2005 Annual Report

Shepley's Hill Landfill Long Term Monitoring & Maintenance Devens, Massachusetts

Appendix H
Response to Comments

Figure 5-1
Contour Map of Baseline (Pre-Test) Groundwater Elevations
Measured on August 24, 2005

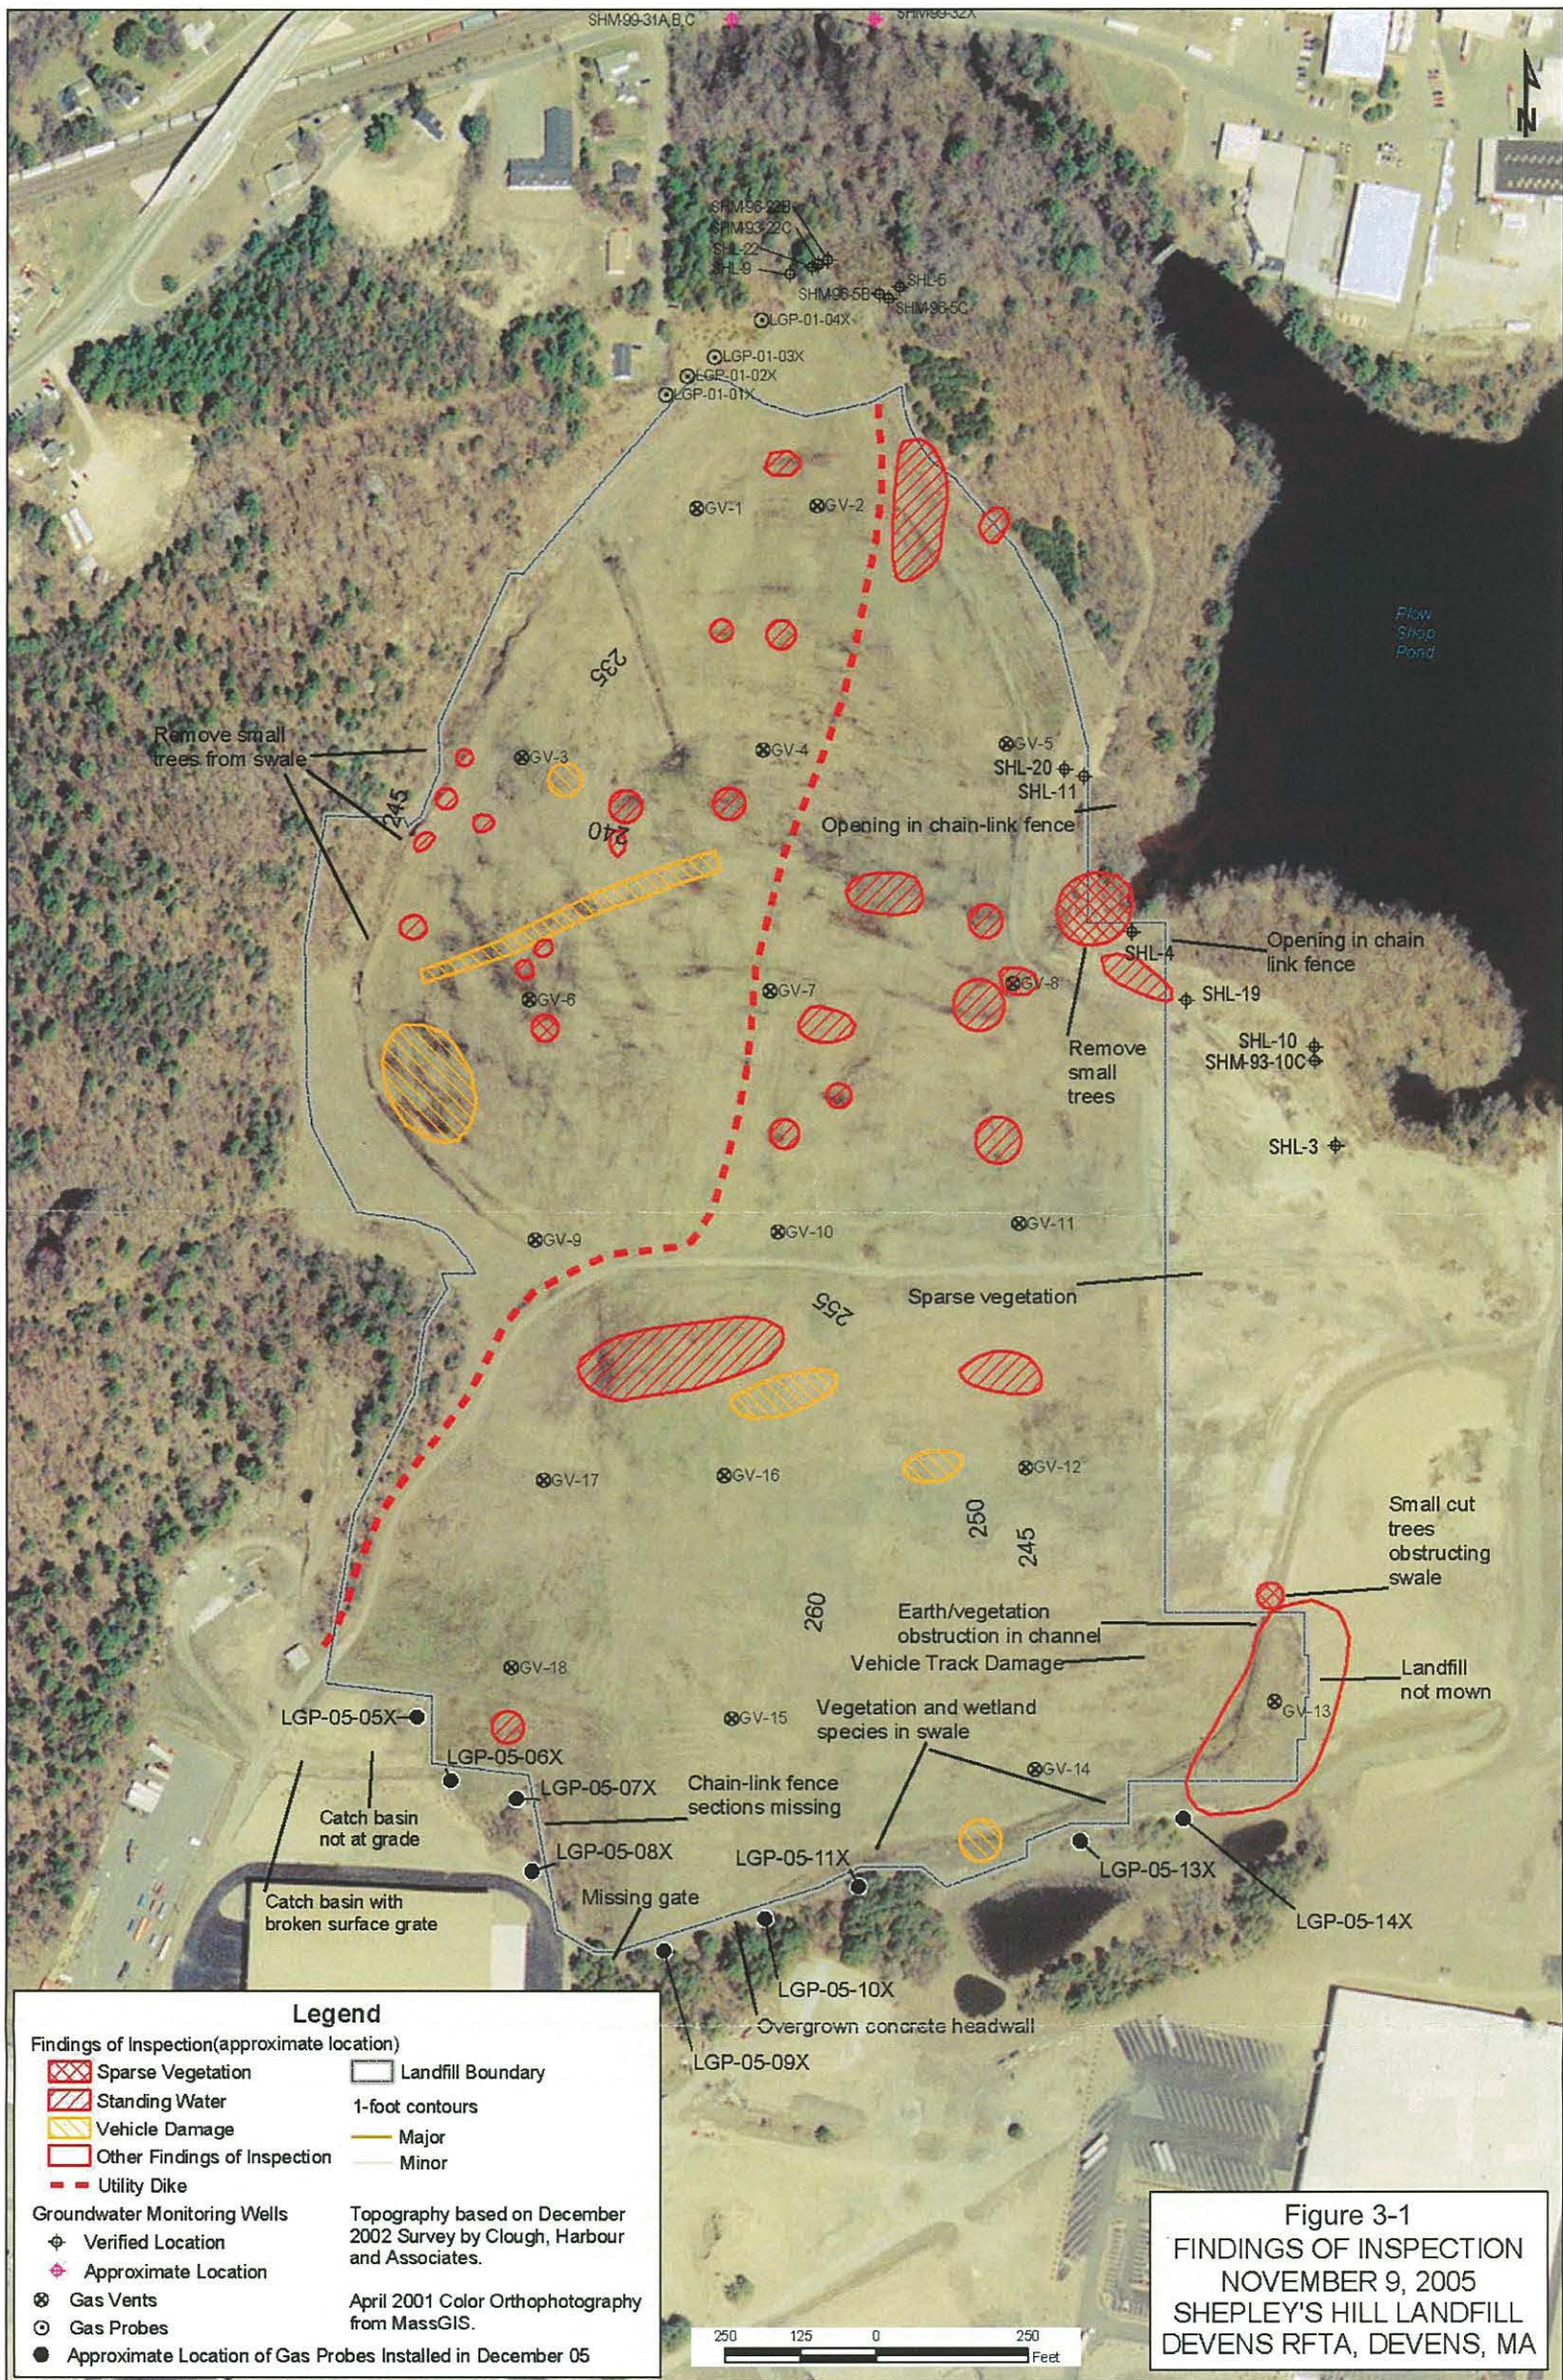
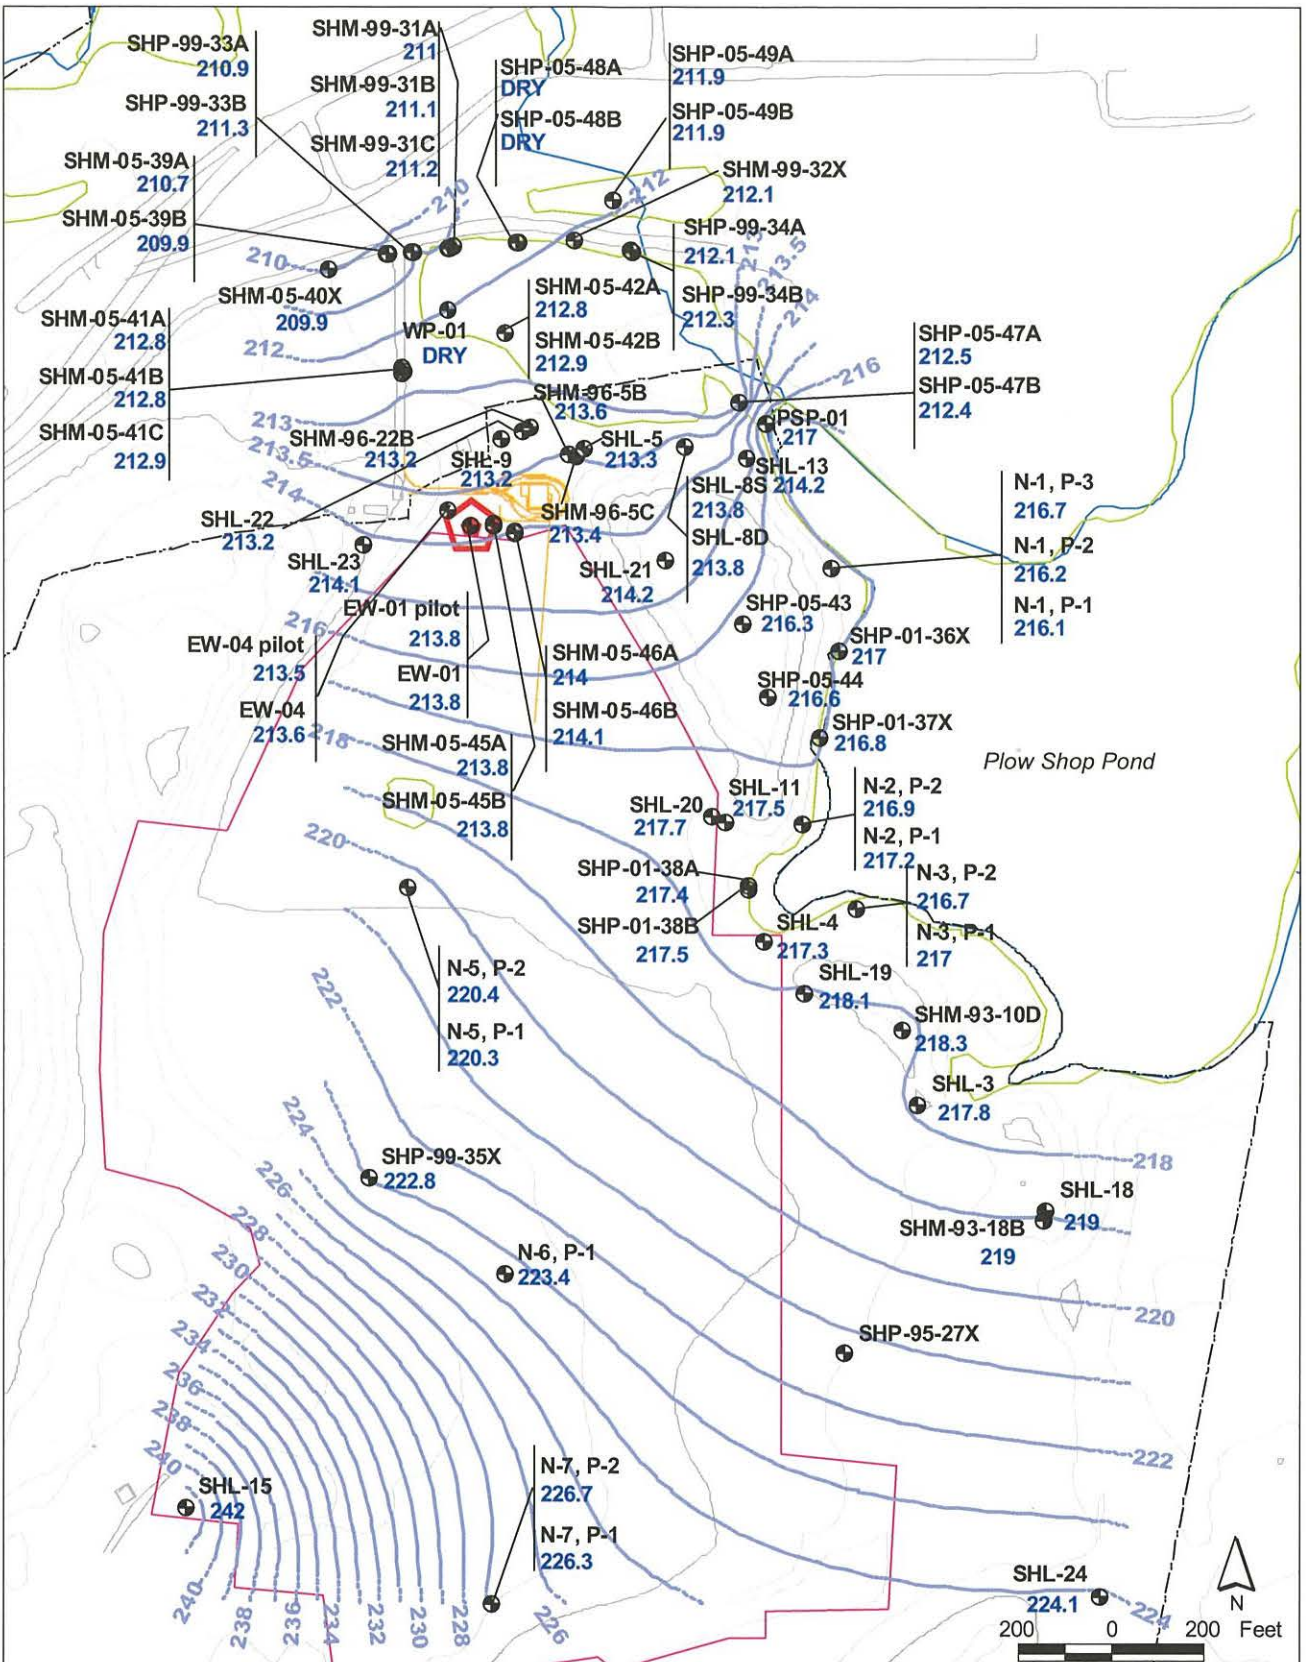
4. Section 5.0, Page 7, 2nd Para: This section states that groundwater levels were measured on August 24 and August 26, 2006, as part of the extraction test. The data in Table 5-2 indicate that baseline water levels were measured on 8/24/2005 and maximum drawdown was measured on 8/26/2006. Also, water level elevations are shown on Figures 5-1 and 5-2 for pre-test and maximum drawdown conditions, respectively. The figure captions indicate that these measurements were taken on August 24 and 26, 2005. Please correct these dates.

Army Response: Corrections relating to date references will be made.
